Permit No: PRRES20210293  
Plan Name: 3022 NW THOREAU PL  
Project Address: 3022 NW THOREAU PL, LEES SUMMIT, MO 64081  
Parcel Number: 225580  
Location: WINTERSET VALLEY 13TH PLAT LOTS 1472 THRU 1487 --- 1475  
Type of Work: NEW SINGLE FAMILY

### Residential Plan Review

STRUCTURAL REVIEW  
HD ENGINEERING & DESIGN  
HD: 40681 DATE: 2/4/2021

FRONT ELEVATION  
SCALE: 1/4" = 1'-0"

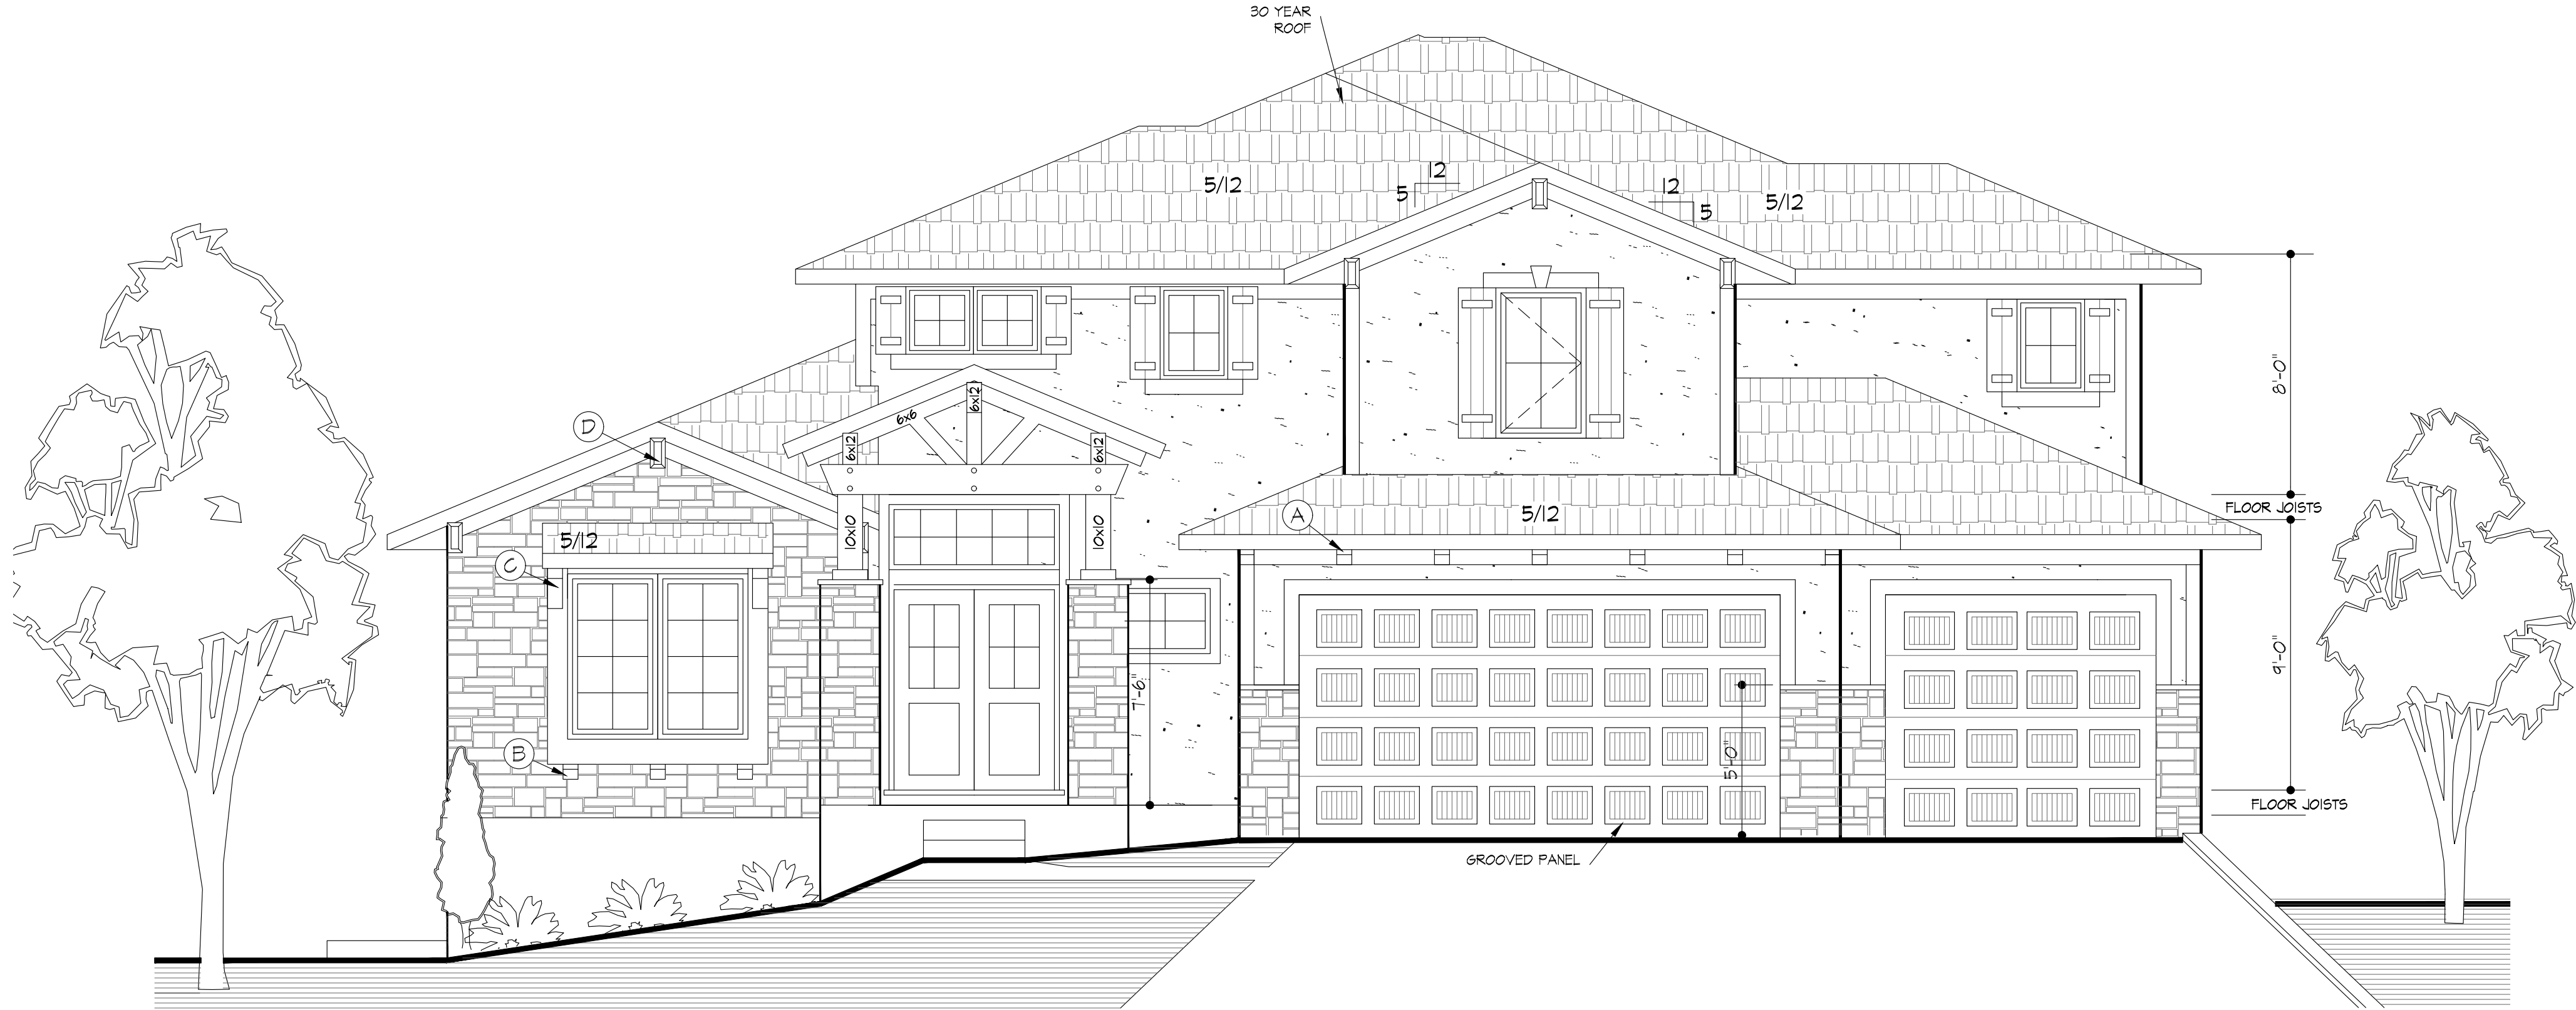
1. Identify roof covering material (IRC Section R905)  
**SEE CLOUDED FRONT ELEVATION**
2. Identify braced wall locations and length of braced wall panel(s). (IRC Section R602.10)  
**SEE CLOUDED PLAN CHANGES**
